PART LIST		MATERIAL SPECIFICATION SST	
UNLESS OTHERWISE SPECIFIED DIMENSIONS ARE IN INCHES DECIMALS ARE FINISH SIZE ± .03 & 1/16 125/1000 ± .010 UNLESS OTHERWISE SPECIFIED UNLESS OTHERWISE SPECIFIED UNLESS OTHERWISE SPECIFIED		CONTRACT OR SALES ORDER NO.	
THIRD ANGLE PROJECTION		APPROVALS	7000#
DO NOT SCALE DRAWING		CHECKER	DATE
CADD FILE NAME: C:\96\6028\4103280.DWG		ENGINEER AH	3/15/96
SCALE: 1=8		TITLE: ASSEMBLY DWG G44 ELECTRIC	
SHEET 1 OF 1		Dwg. NO. 103280

L1G0-D961195-B-B

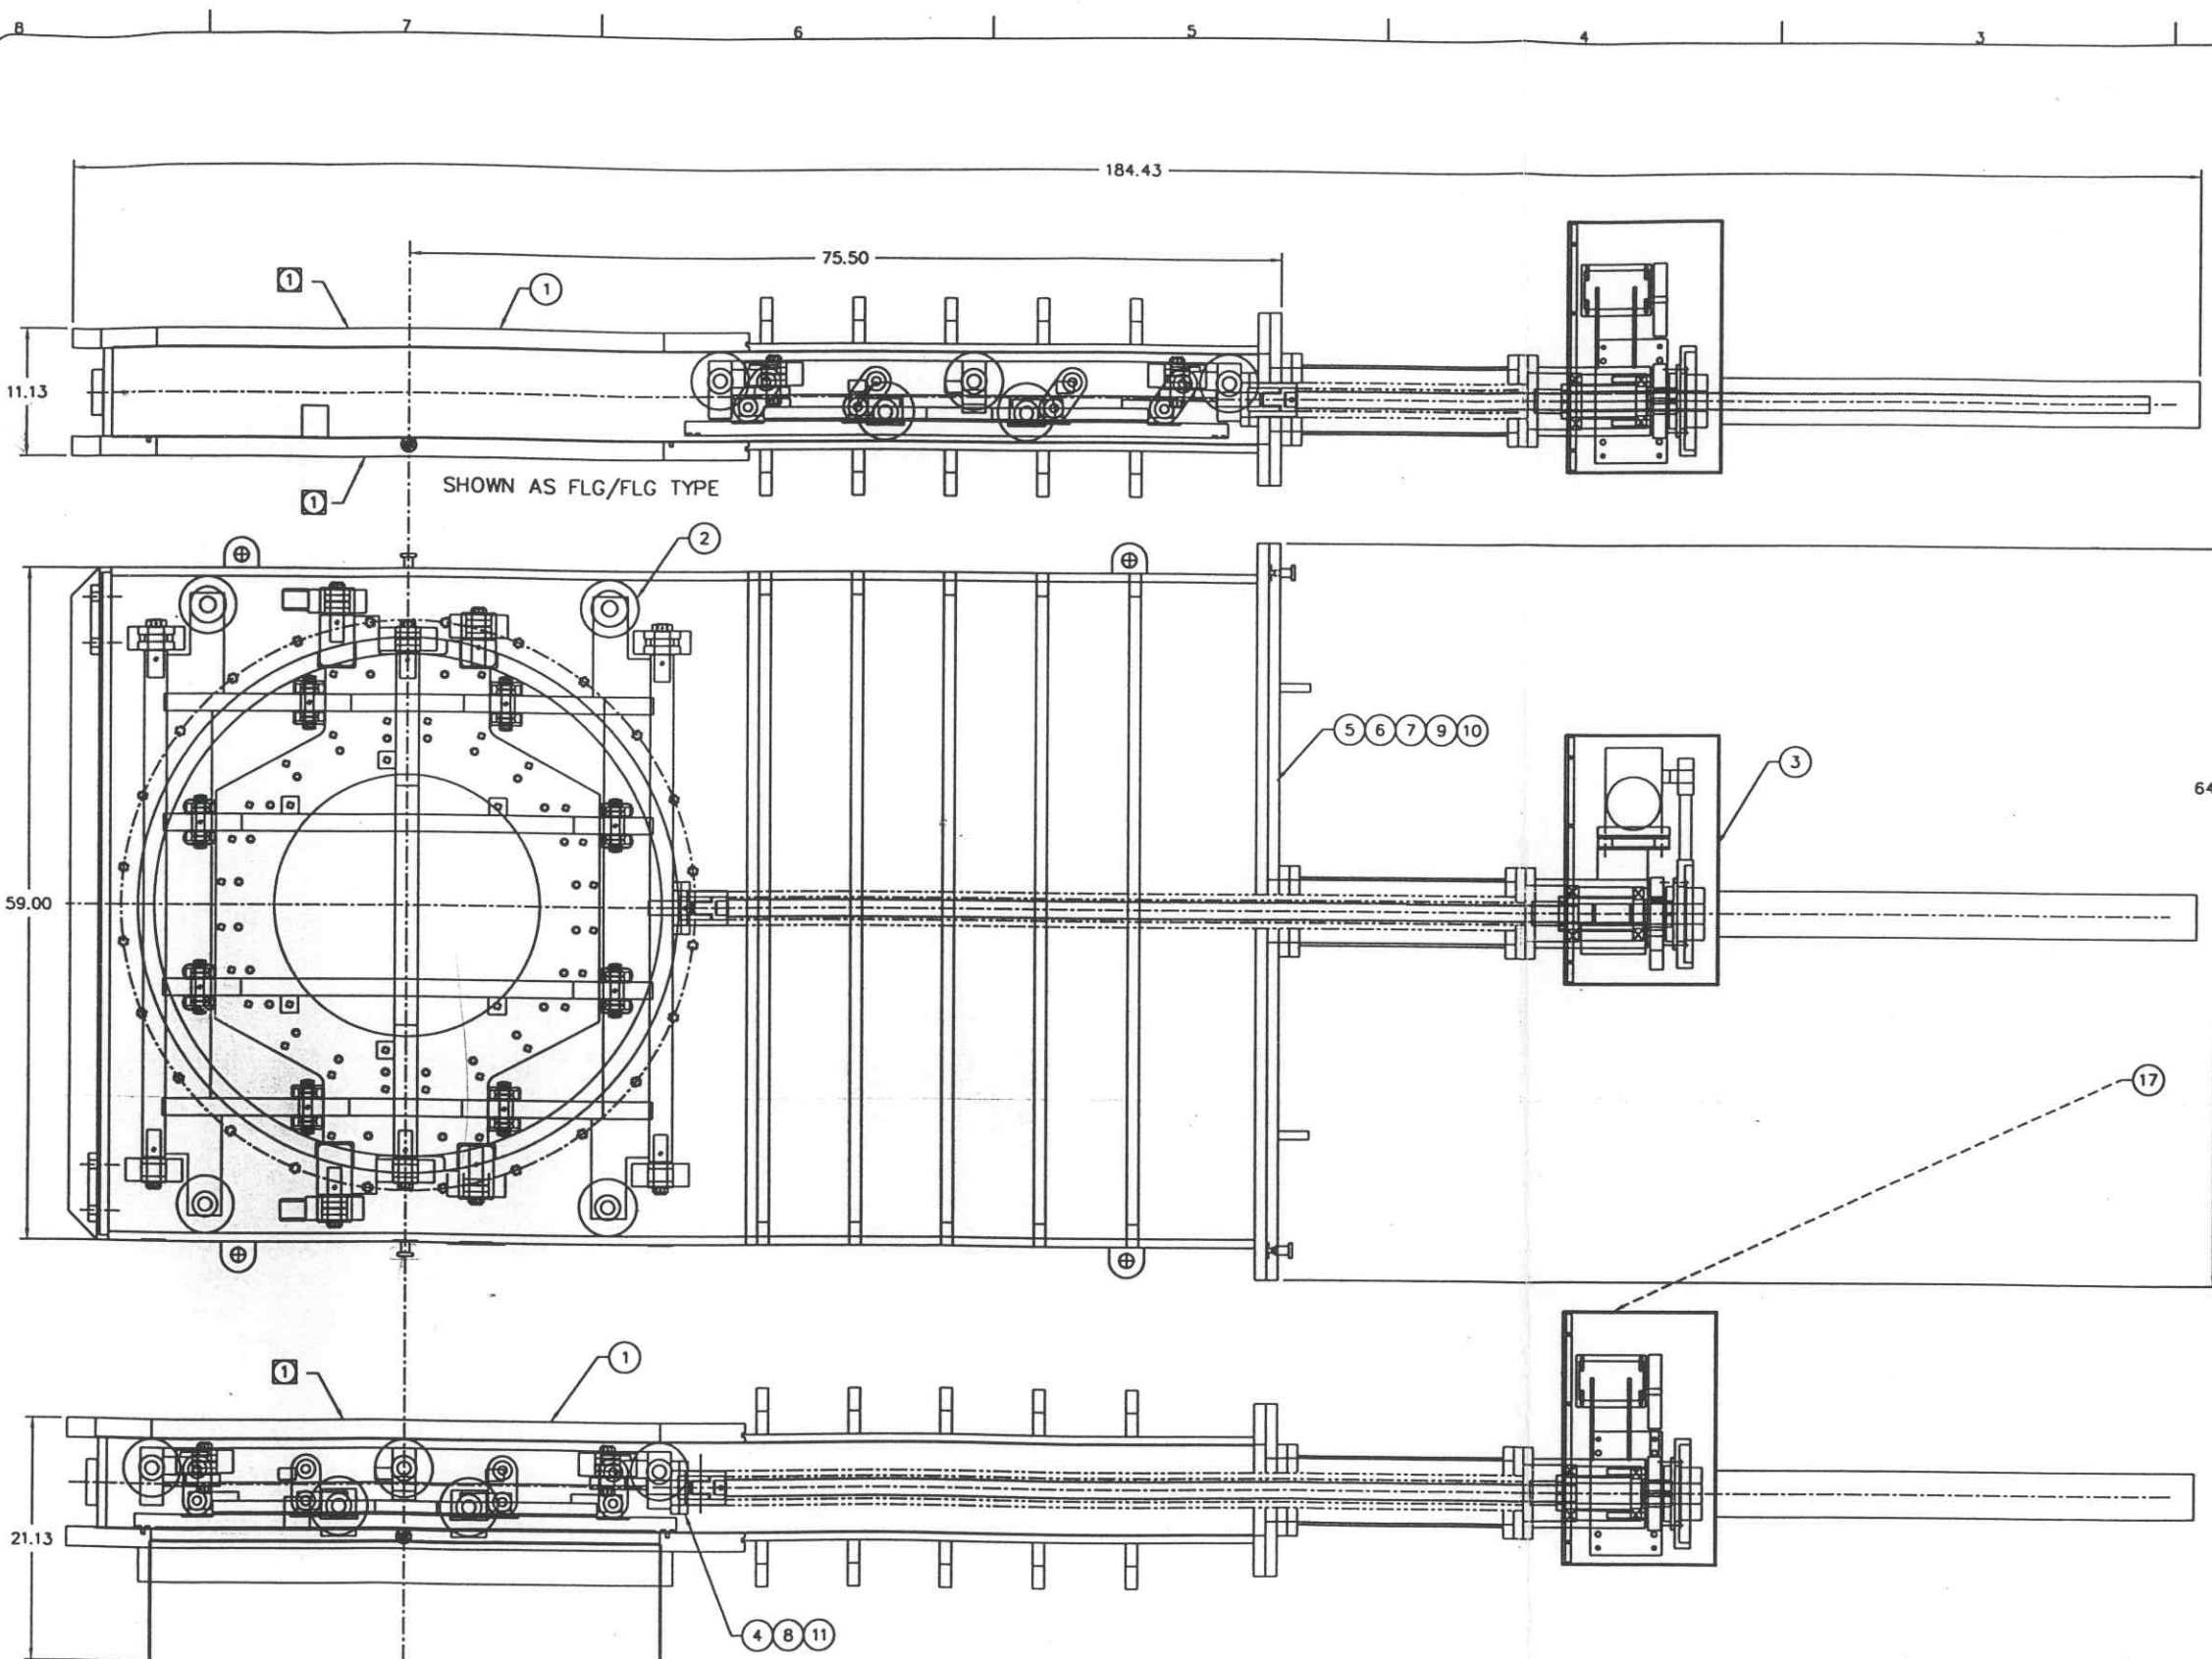
BONNET O-RING GROOVES
IN BODY PLATE, NOT BONNET PLATE

SHOW MOTOR CONTROLLER AND
MOUNTING PLATES ON BOTH SIDES
OF VALVE FOR FIELD CHOICE.
ALSO, SHOW NOTE TO REMOVE
CONTROLLER FOR SHIPPING
